Water Resources Decision Statement for an application for a water abstraction licence at Gore Quarry, Walton, Presteigne, Powys.

Application number: PAN-023639

Licence number: WA/055/0008/0006

Map 1

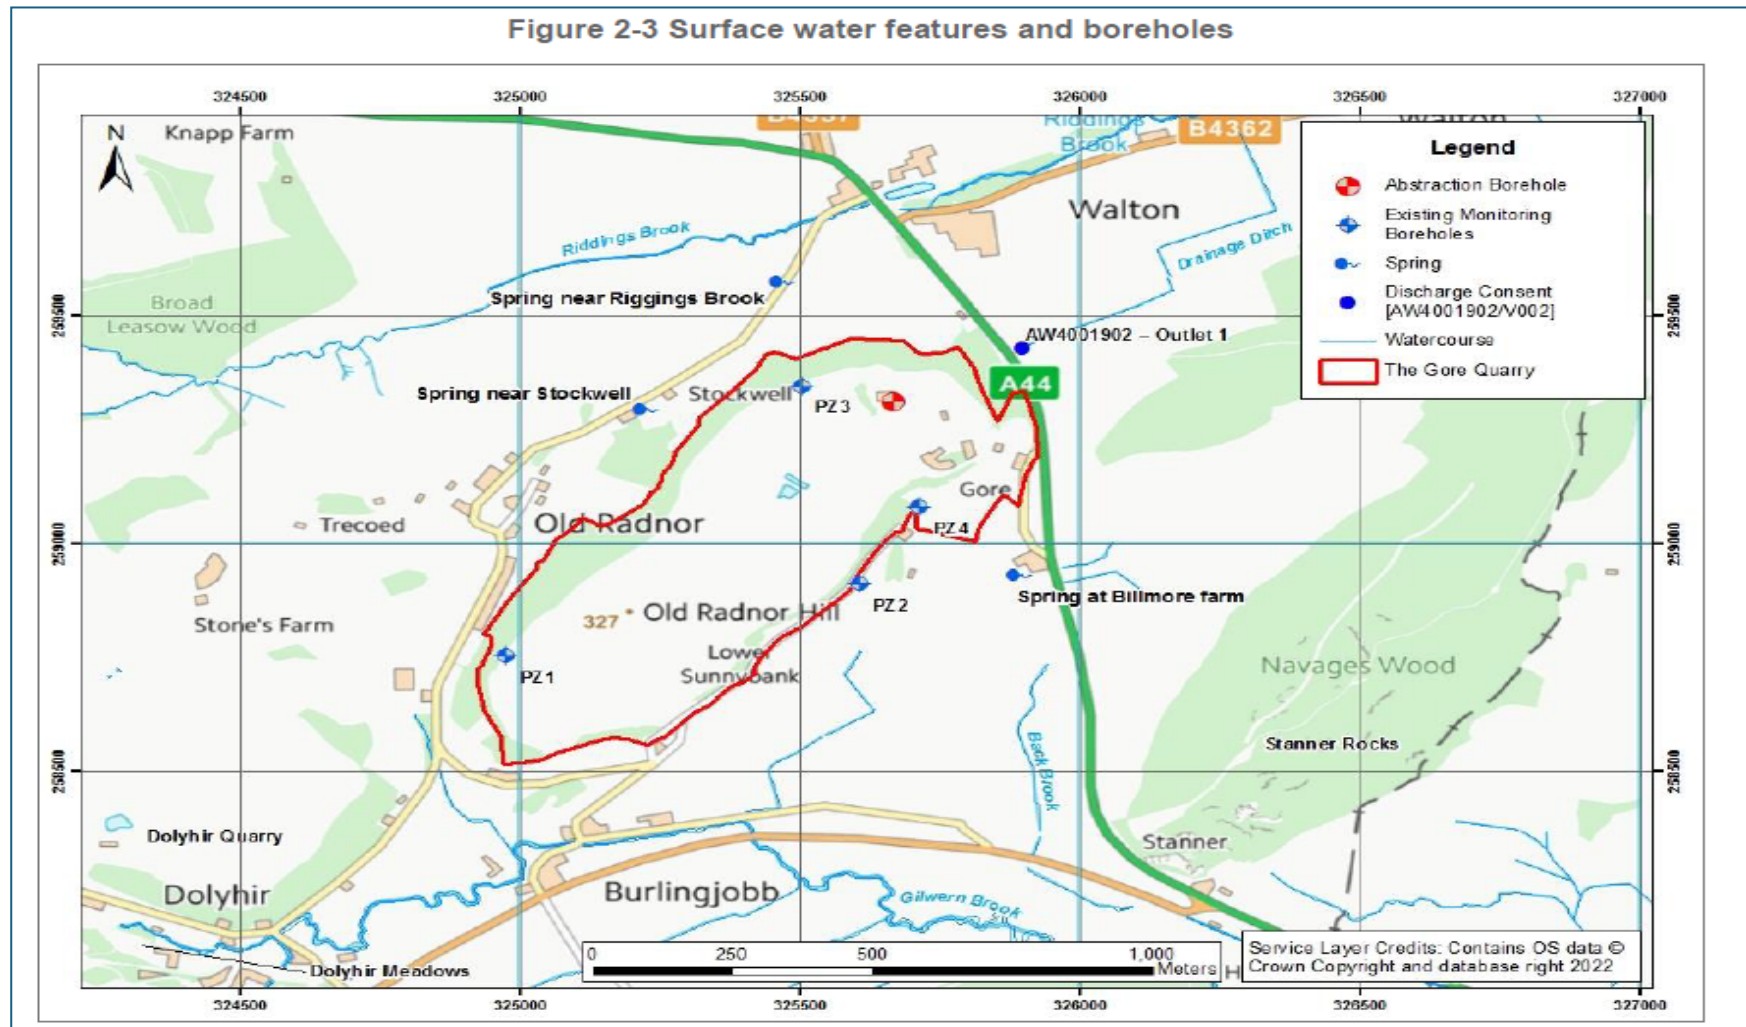
Four piezometers (also monitoring the Strinds Formation) around the quarry were used for monitoring during the test pump (*see map 1 below*). Non-pumping, the piezometers showed that groundwater levels are higher in the South West corner of the site and reducing in elevation to the North East, implying a groundwater flow direction towards the North East. The springs at Bilmore Farm, Riddings Brook and Stockwell were visually observed during the test pump period. No flow was observed during the testing period. The springs are not used for potable water supply. Therefore, it was concluded that the spring were not at risk of derogation from the abstraction.

Only PZ3 showed any noticeable effect from abstraction at the borehole. This is located close the abstraction borehole and to the west. PZ4 is the next closed monitoring location which does show a response to abstraction from the borehole. This indicates that the cone of depression from the abstraction borehole will remain within the confines of the quarry and derogation of local water features and users is limited and unlikely.
